Urgent Field Safety Notice

StealthStation™ S8 App version 2.0 and 2.0.1 (Model # 9735762)

StealthStation™ S8 and StealthStation FlexENT™ Software Plan Data Shift with New Reference Exam Notification and warning & instructional placard placement

Medtronic Reference: FA1361

Figure 3. Pre-Merge/Diffusion Merge with Reference

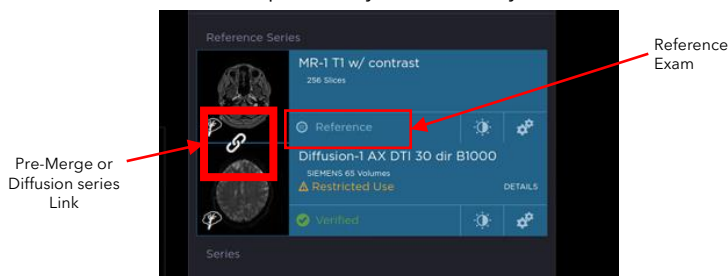
1. The navigation reference exam is merged with either a diffusion series (for tractography processing) or a pre-merge type series (an exam that does not contain anatomical information that must already be aligned or pre-merged to the anatomy in the reference exam - examples are a functional MRI activation map overlay or a PET exam).

Note: The icon link in **Figure 3**, below indicates the use of pre-merge or diffusion merge. Merged images without this icon link is not impacted by this anomaly.

Medtronic recommends that users do not change the reference exam after establishing a surgical plan if the original reference exam included pre-merge or diffusion merge exam. The incorrect surgical plan data **cannot** be recovered by reverting to the original reference exam. To resolve this issue, the user must manually update the existing plans to the original locations or make new plans.

Figure 4. Pre-Merge/Diffusion Merge with changed Reference

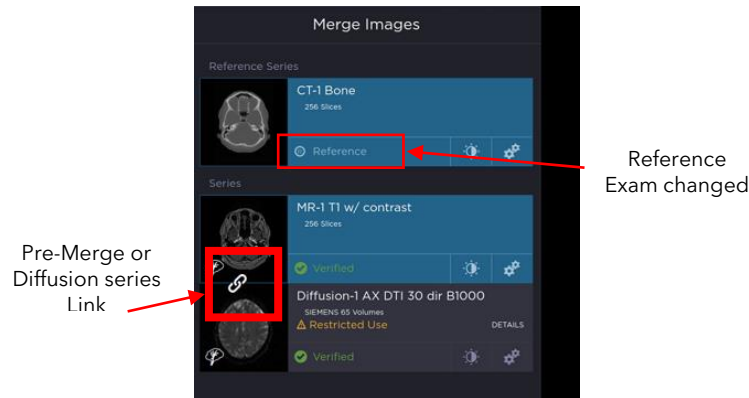
- The reference exam is changed to a different exam as seen in **Figure 4**, below.
